Technical Note

Subject: Dinting Vale - Air Quality Assessment Technical Note

Table 1-1: HPBC response

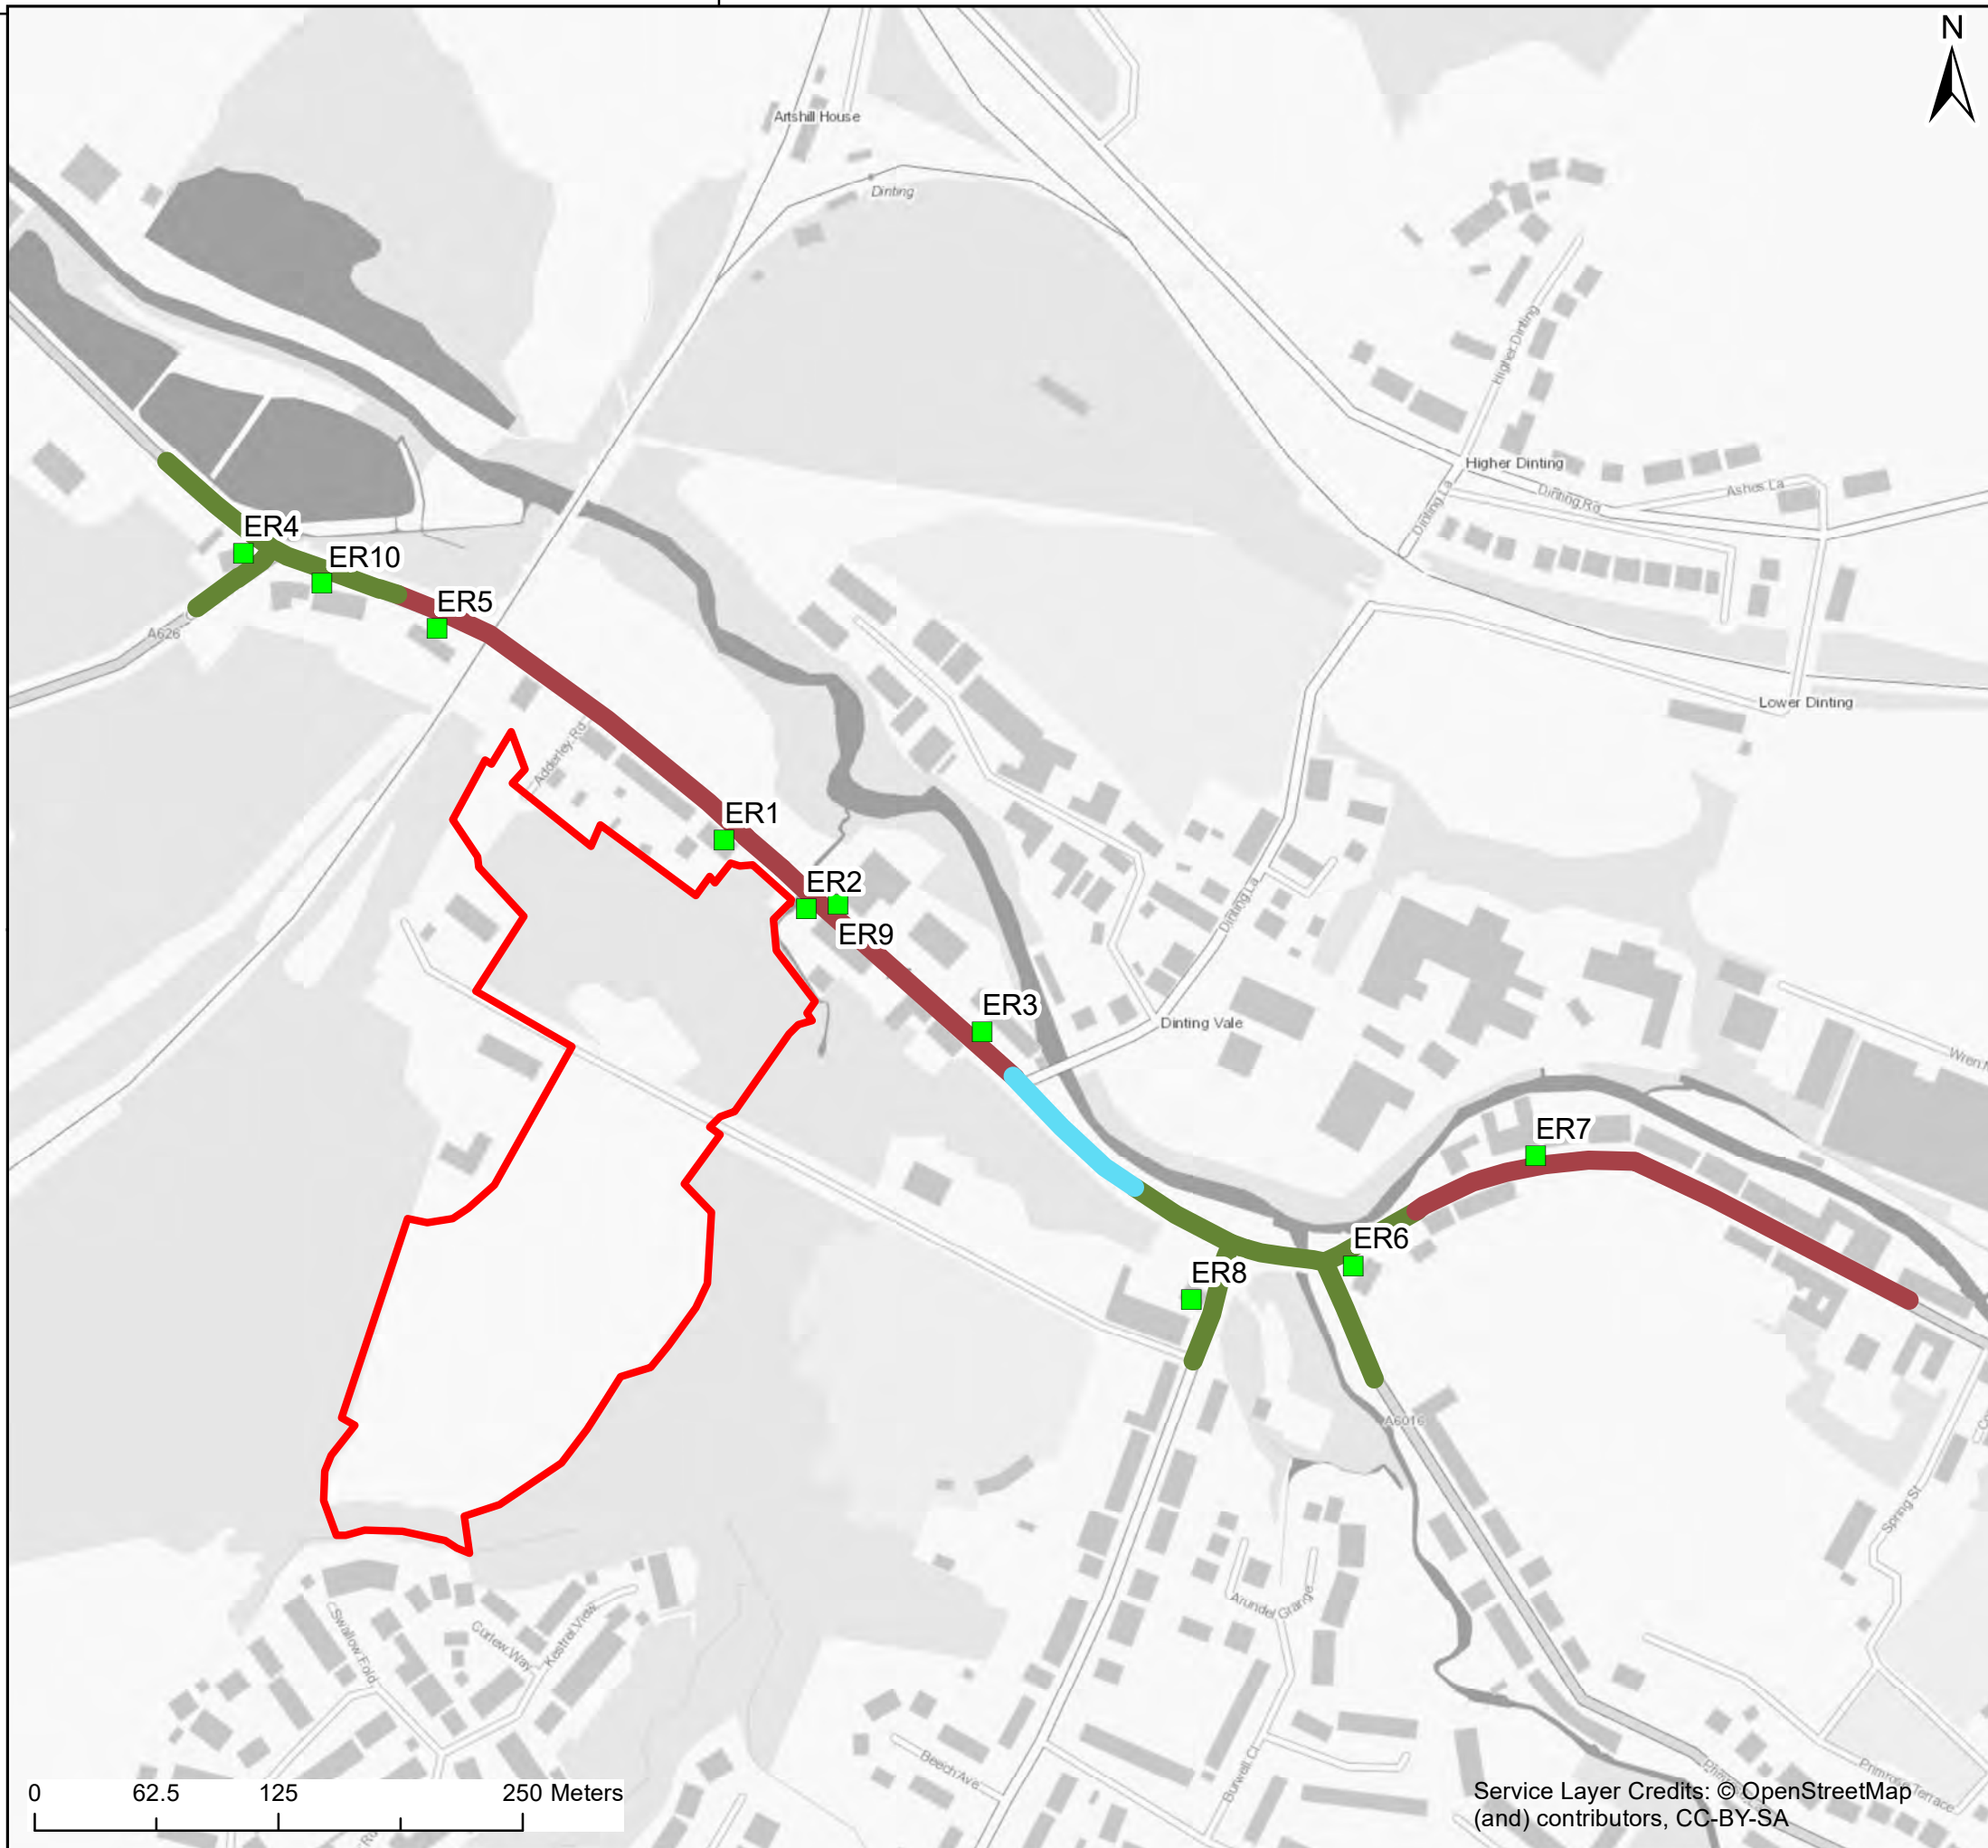
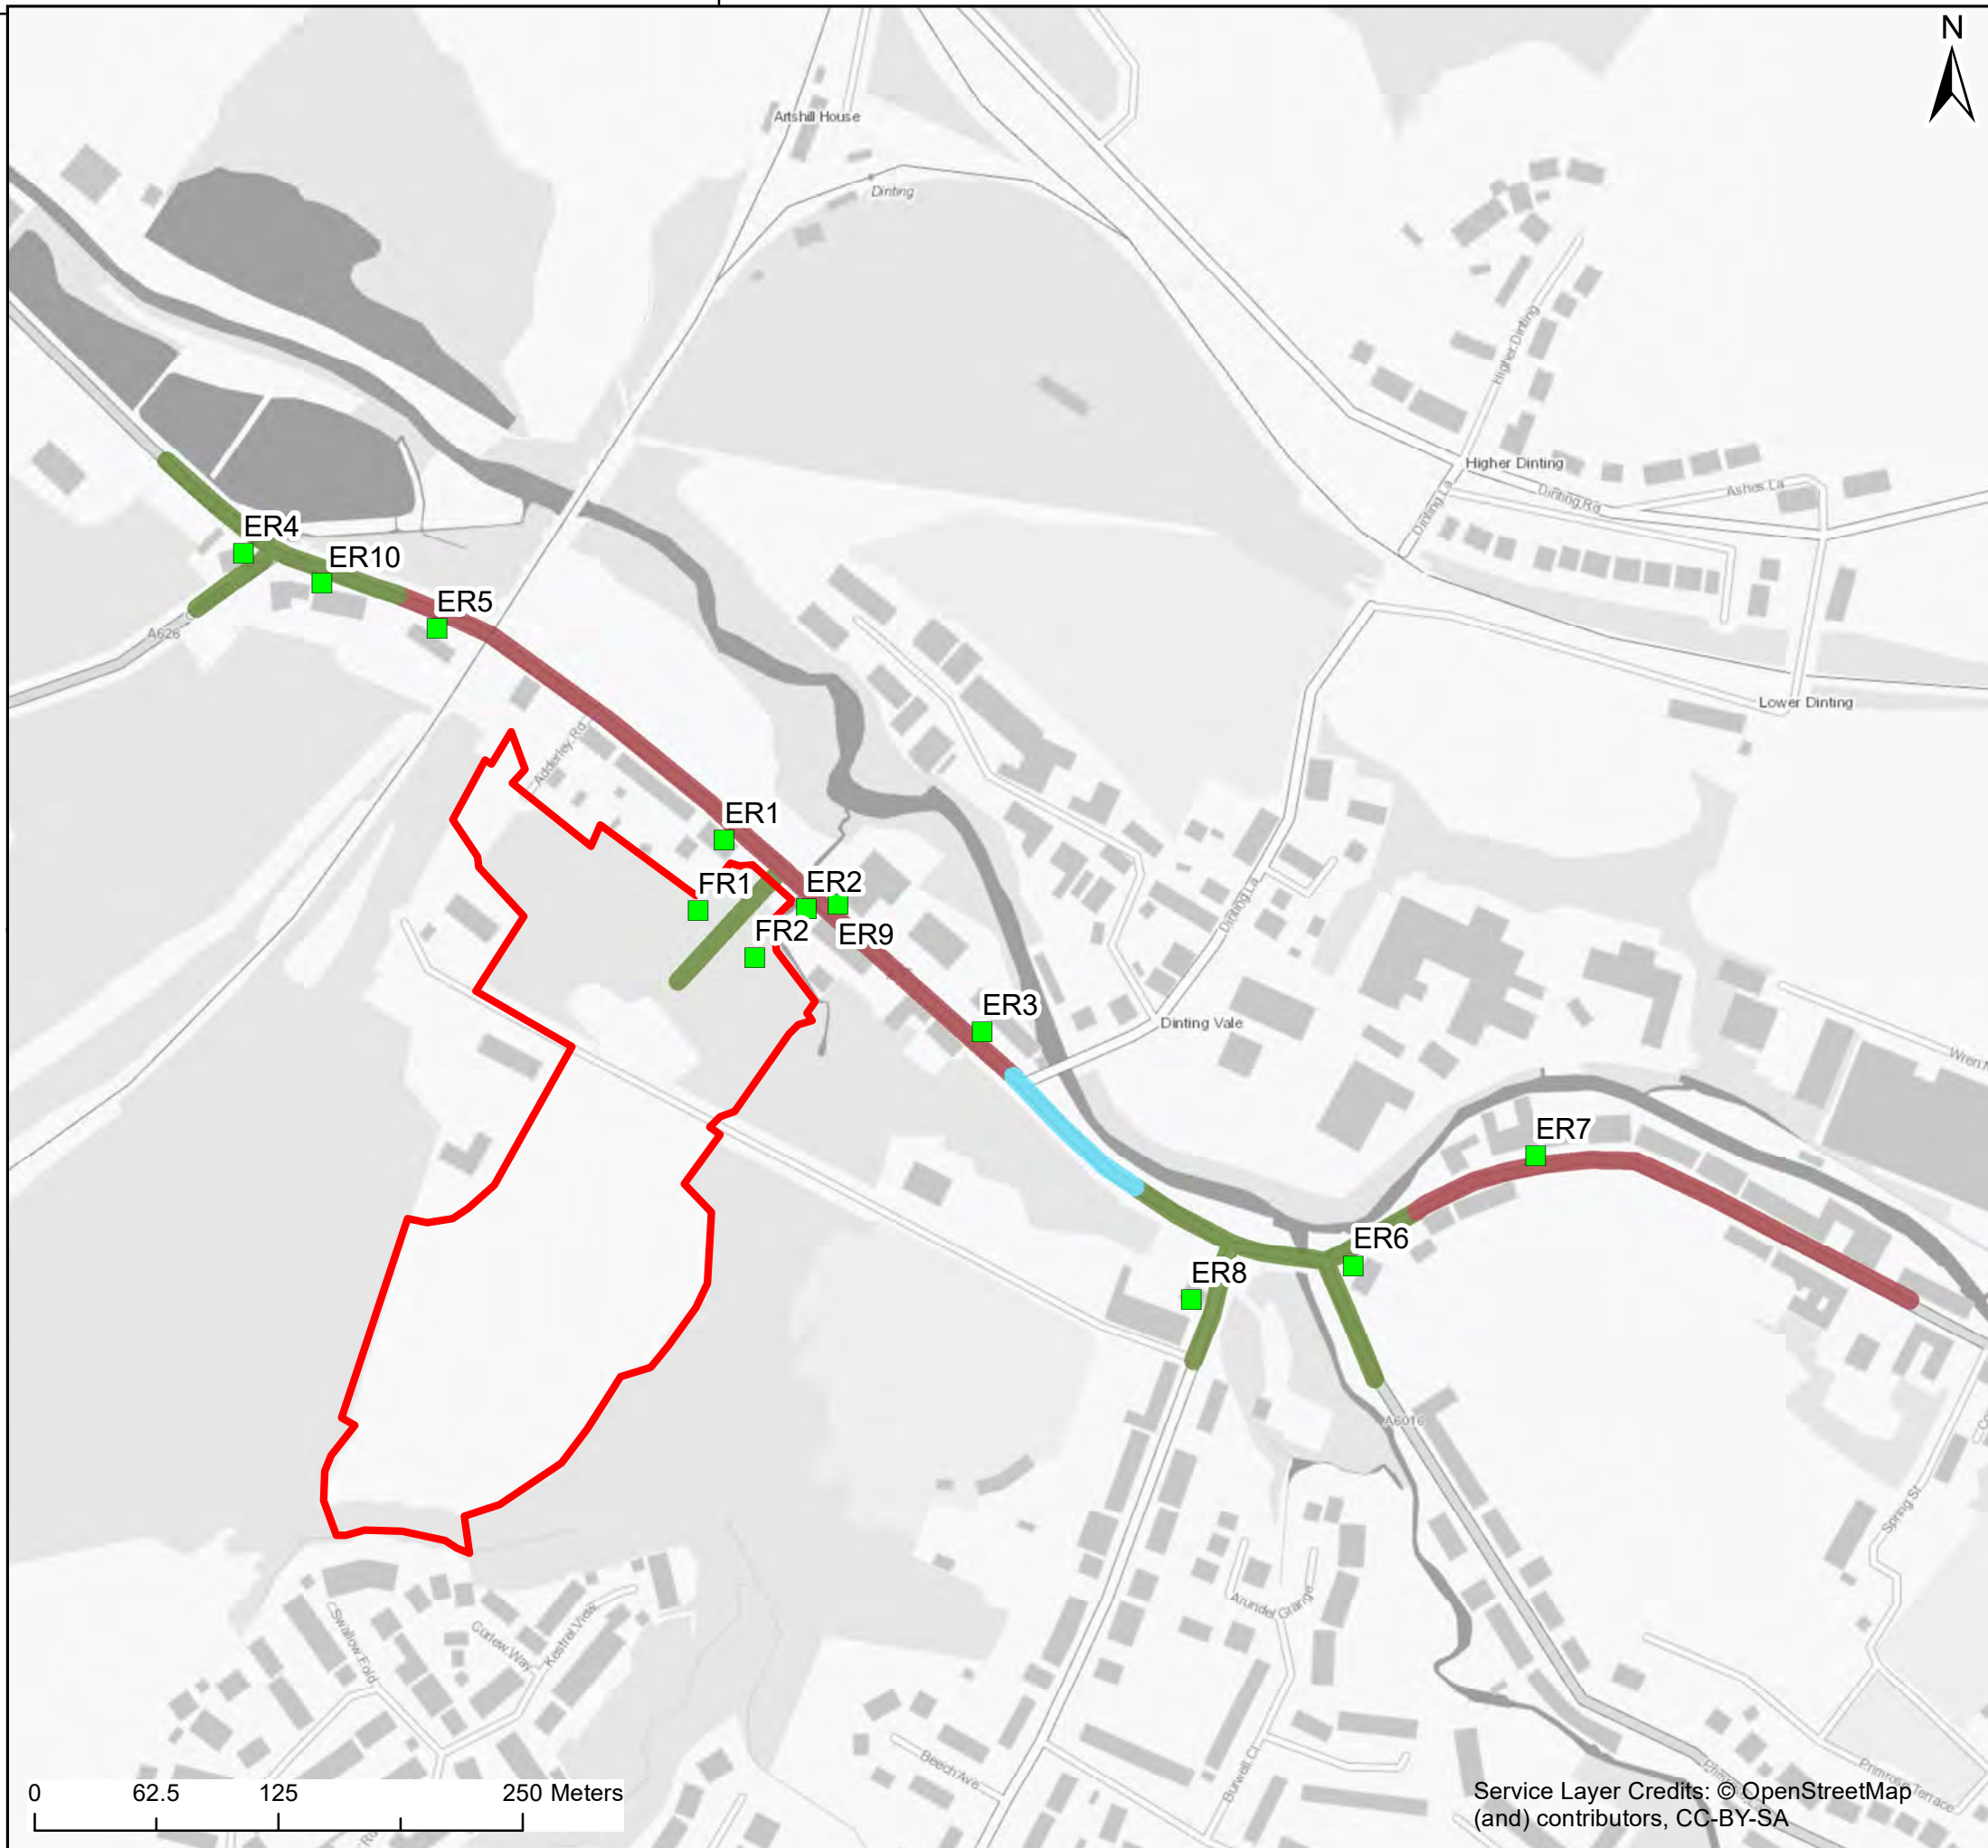
- The 5km/h is agreed but the extent to which these were applied and where they were applied is not clear. The author notes (in explaining the setting up of the base the model) that the discrepancy between the actual data at HP21 (primary school) being higher than the modelled data is in part due to the bus stop and traffic lights meaning interrupted flow/ point sources emissions (...and this is hard to model). This is agreed in part will be interesting to see the speed attributed to this part of the road.

- and,
 - Speed data for free-flowing traffic conditions were obtained from national speed limits
Again the extent of where the free flowing traffic conditions were applied is not clear, it should also be noted that the updated traffic technical note undertook a speed count and noted seven-day average 85th percentile speeds of Northbound 28.7mph and Southbound 25.3mph not 30 mph.

It would be better if this was represented graphically detailing exactly the areas where the differing speeds were applied

Date / Document	Request*	Response
	<p>technical note which includes information on for example traffic speeds.</p> <p>The 5km/h is agreed but the extent to which these were applied and where they were applied is not clear. The author notes (in explaining the setting up of the base the model) that the discrepancy between the actual data at HP21 (primary school) being higher than the modelled data is in part due to the bus stop and traffic lights meaning interrupted flow/ point sources emissions (...and this is hard to model). This is agreed in part will be interesting to see the speed attributed to this part of the road.</p> <p>There is also no indication that in the do something scenario, any possible changes in flows as a result of the junction to the new development have been considered – if there is no effects it should be noted. Will the change in the bus location affect flows and impact on receptors if moved closer to receptors?</p> <p>Again, the extent of where the free flowing traffic conditions were applied is not clear, it should also be noted that the updated traffic technical note undertook a speed count and noted seven-day average 85th percentile speeds of Northbound 28.7mph and Southbound 25.3mph not 30 mph.</p> <p>It would be better if this was represented graphically detailing exactly the areas where the differing speeds were applied</p>	<p>The speed attributed to the section of road adjacent to the bus stop has been modelled at a speed of 20 km/h. This is considered adequate to capture the emissions from the bus stop. In regard to the relocation of the bus stop, as the majority of Dinting Vale Road has been modelled at a speed of 20 km/h, it is considered the modelling is sufficiently robust to capture the relocation of the bus stop.</p> <p>As shown on Figure 2.0 in Appendix B, the access road to the Proposed Development has been modelled at a speed of 5 km/h. The ‘with development’ scenario therefore includes the predicted impact of the new junction at the adjacent existing receptors, as well as the future receptors within the Proposed Development. Given that Dinting Vale has already conservatively been modelled at a speed of 20 km/h, it is not considered the volume of traffic generated by the Proposed Development will have a significant impact on traffic speeds along this road link.</p> <p>It is therefore considered that the results of the modelling included in the report referenced PC4629-RHD-ZZ-XX-RP-Z-0001 are robust.</p>
